MIPS modules for Lab-4, Data Forwarding

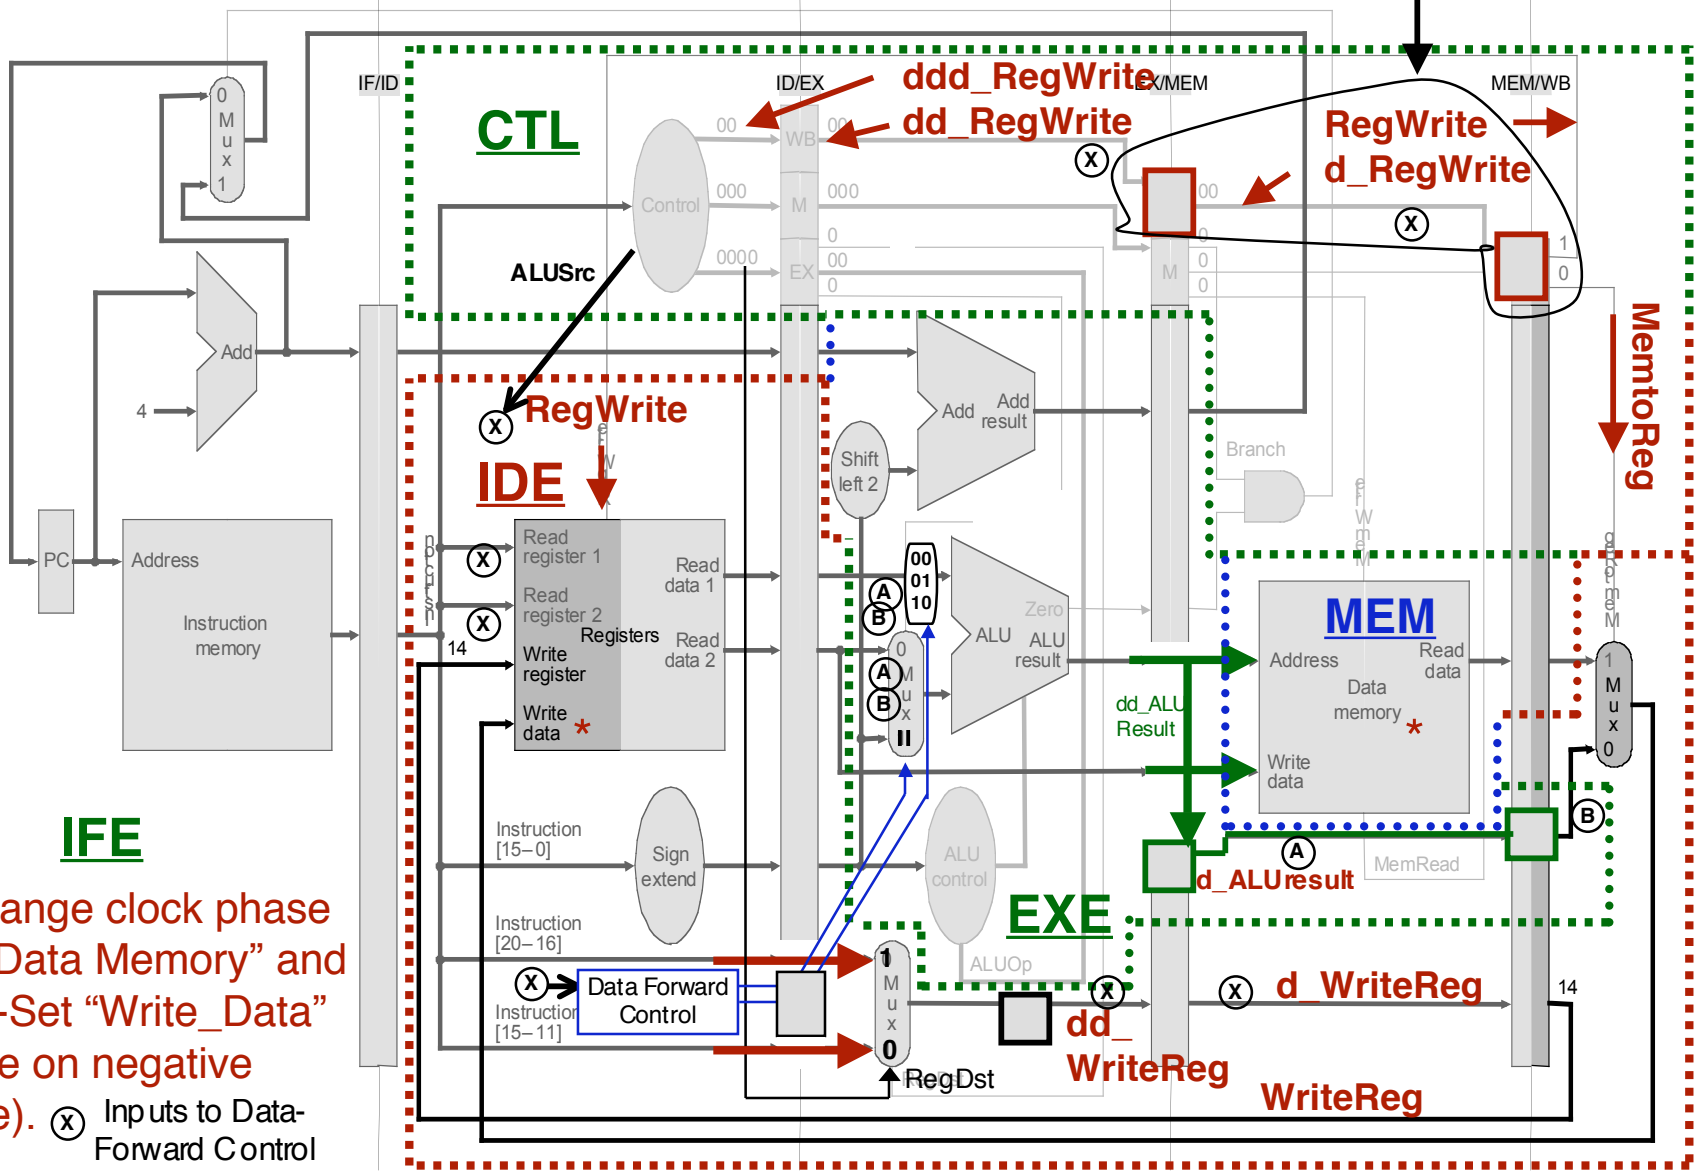
Move RegWrite to IDE

* Change clock phase for “Data Memory” and Reg-Set “Write_Data” (write on negative edge). (X) Inputs to Data-Forward Control
